PRODUCT CHANGE NOTIFICATION (PCN)

A-MCSP60100/Y MODULAR CABLE

CHANGE NOTIFICATION: PCN 20220822_A-MCSP60100/Y

DESCRIPTION OF CHANGES: CHANGE OF DATA SHEET
CHANGE OF DATA SHEET
New Draw.-No. ASS_7542_CAreV06

ASSMANN WSW P/N	Drawing Number		ASSMANN WSW P/N	Drawing Number
A-MCSP60100/Y	ASS_7542_CArev05	↔	A-MCSP60100/Y	ASS_7542_CArev06

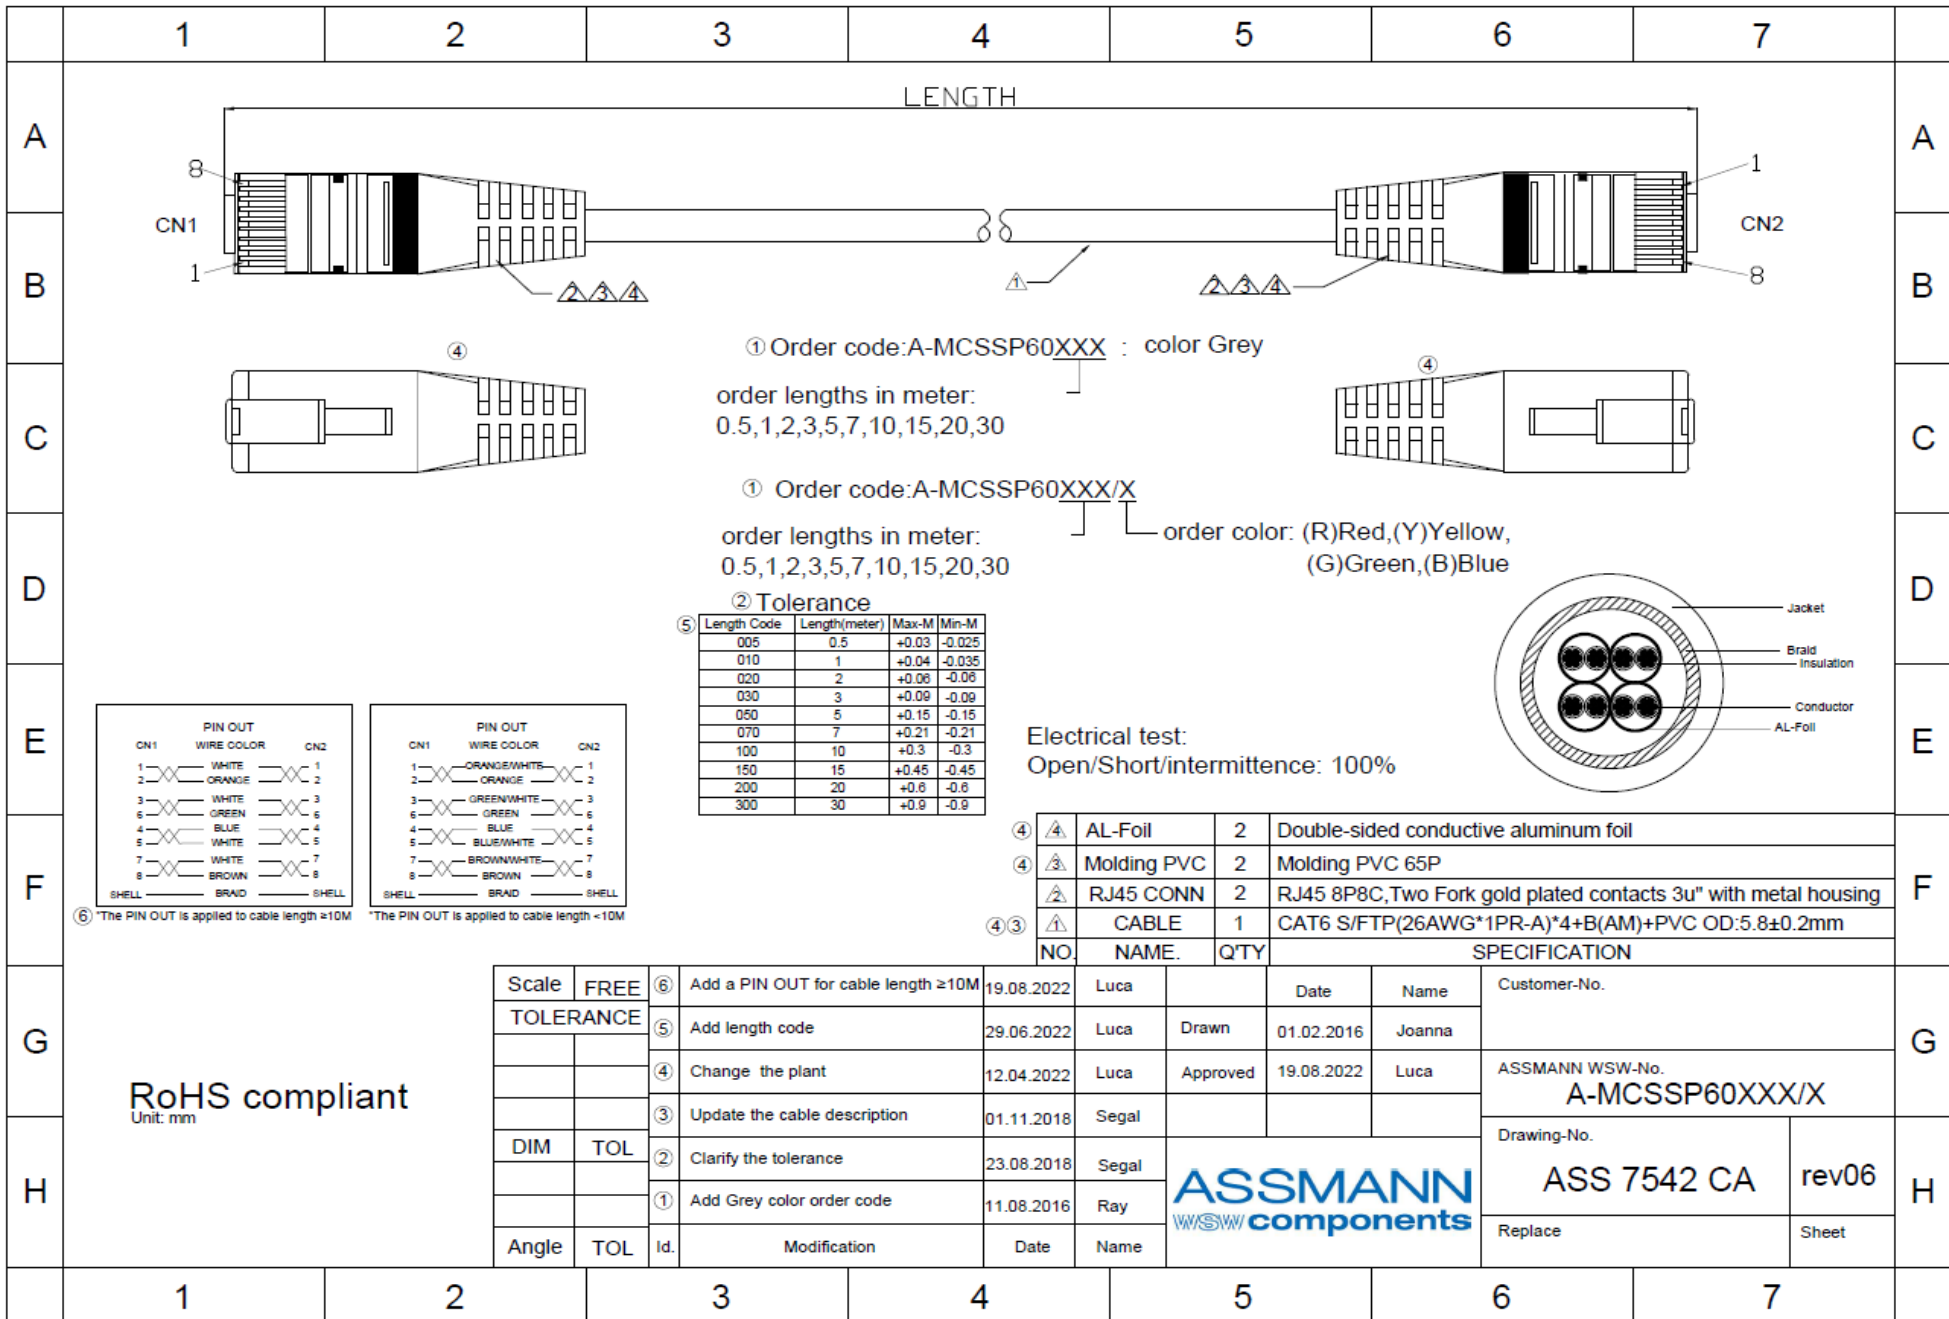
REASON FOR CHANGE: CHANGE OF MATERIAL PARAMETERS OR PROPERTIES
CHANGE OF MATERIAL PARAMETERS OR PROPERTIES

SHELL	BRAID	SHELL																																																																																									
CN1	WIRE COLOR	CN2																																																																																									
1	WHITE	1																																																																																									
2	ORANGE	2																																																																																									
3	WHITE	3																																																																																									
6	GREEN	6																																																																																									
4	BLUE	4																																																																																									
5	WHITE	5																																																																																									
7	WHITE	7																																																																																									
8	BROWN	8

⑥ *The PIN OUT is applied to cable length ≥10M *The PIN OUT is applied to cable length <10M

Scale	FREE	⑥	Add a PIN OUT for cable length ≥10M	19.08.2022	Luca		Date	Name	Customer-No.
TOLERANCE		⑤	Add length code	29.06.2022	Luca	Drawn	01.02.2016	Joanna	ASSMANN WSW-No. A-MCSSP60XXX/X
		④	Change the plant	12.04.2022	Luca	Approved	19.08.2022	Luca	
		③	Update the cable description	01.11.2018	Segal				
DIM		TOL	②	Clarify the tolerance	23.08.2018	Segal			
			①	Add Grey color order code	11.08.2016	Ray			
Angle		TOL	Id.	Modification	Date	Name	Replace	Sheet	H
